PRODUCT SUPPORT BULLETIN # 334

6223 Two Speed BANDSAW, with Starting Serial Number 822B  
6225 Two Speed BANDSAW, with Starting Serial Number 457B  
6227 Speed Control BANDSAW, with Starting Serial Number 674B

**SUBJECT: Correction to Service Parts List Bulletin 54-40-0051, 54-40-0117 & 54-40-1211**

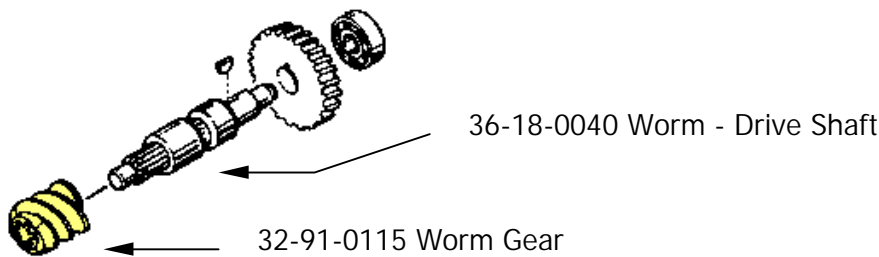
6223, 6225 & 6227 BandSaws with starting Serial Number 457**B**, 674**B** or 822**B** have a potential to contain a 'one piece' Worm Drive Shaft (*see illustration*) versus the 'two piece' Worm & Worm - Drive Shaft as shown on the Service Parts List Bulletin.

Some 6223, 6225 & 6227 BandSaws within the '**B**' series were produced with a 'one piece' Worm Drive Shaft 36-18-0041.

54-40-0051, -0117 & -1211 Service Parts List Bulletins call out the 'two piece' the 32-91-0115 Worm and 36-18-0040 Worm Drive Shaft.

Please Note! 36-18-0040 Worm Gear Shaft is 'OBSOLETE – replaced by' the 36-18-0041 'one piece' Worm - Drive Shaft. The 32-91-0115 remains a 'saleable' Service Replacement Part for use in 6225, 6227 BandSaws and 6377, 6378, 6387, 6388 7-1/4" Worm Drive Saws.

This bulletin is for informational purposes; PLEASE NOTE ON SERVICE PARTS LIST BULLETIN: DOMESTIC, 54-40-0051, -0117, & -1211
